From: Harry Chalk
Sent: 12 November 2025 15:49
To: Planning.Responses
Subject: FW: FP/159/25/DOC
Attachments: PC01 - Exsiting site Layout Rev A.pdf; PC02 - Proposed Site Layout. Rev Avwx.pdf

From: Ivon Blumer [REDACTED]
Sent: 12 November 2025 11:49
To: Harry Chalk <Harry.Chalk@arun.gov.uk>
Cc: phillip bendon <[REDACTED]> Planning <Planning@arun.gov.uk>; Planning.Responses <Planning.Responses@arun.gov.uk>
Subject: Re: FP/159/25/DOC

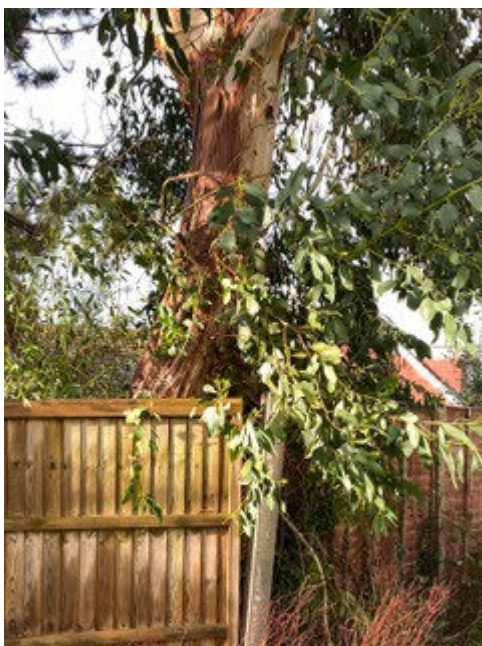
I now refer to condition 9, which requires details of hard and soft landscaping to be provided (these details are generally acceptable), but it also requires indication of the existing trees and hedgerows to be retained and how they will be protected during construction. I can see no details regarding how the hardstanding will be laid without prejudicing the existing trees. My concern primarily relates to the Apple Tree and Eucalyptus Tree within the rear of the site, but all need to be considered. I can see there is an annotation regarding the use of heras fencing, but where hardstanding is to be laid within the root networks of these trees, it is assumed excavations will be necessary (albeit relatively shallow) and it is unclear that the root networks of these trees will not be prejudiced during these works.

Can I request details of how the existing trees/hedgerows to be retained will be protected during construction?

The apple tree is to be retained at the request of the client, it is a very poor specimen, more of a shrub than a tree, with multiple trunks around 75-90 mm in diameter, see attached photo, root protection area (RPA) calculated as 4.0 m diameter based on 4 trunks.

The eucalyptus tree was incorrectly plotted and is in an adjoining garden where the boundary steps, this has a trunk diameter of around 300 mm, see attached photo. RPA calculated as 7.2 m diameter based on 300 mm diameter trunk, as they have shallow roots I have increased this to 10.0 m diameter.

I have shown the relevant RPA's for each tree based on the trunk diameter on drawings 01 Rev A & 02 Rev A, as can be seen the proposed works impact only very slightly on the RPA's, if at all. That said it is our intention to lay the parking spaces over the existing hardcore with 50 mm deep shingle in plastic retaining grids. This will mean that there will be no digging in the parking area adjacent to the above trees, if there is a need for any dig this will be kept to a minimum of 150 mm below existing ground level in the RPA's.

RPA calculated as 12 times trunk diameter at 1.5 m height, apple tree calculated as for multiple trunks.

All trees will be protected with heras fencing as shown on drawing 01 & 02 Rev A.
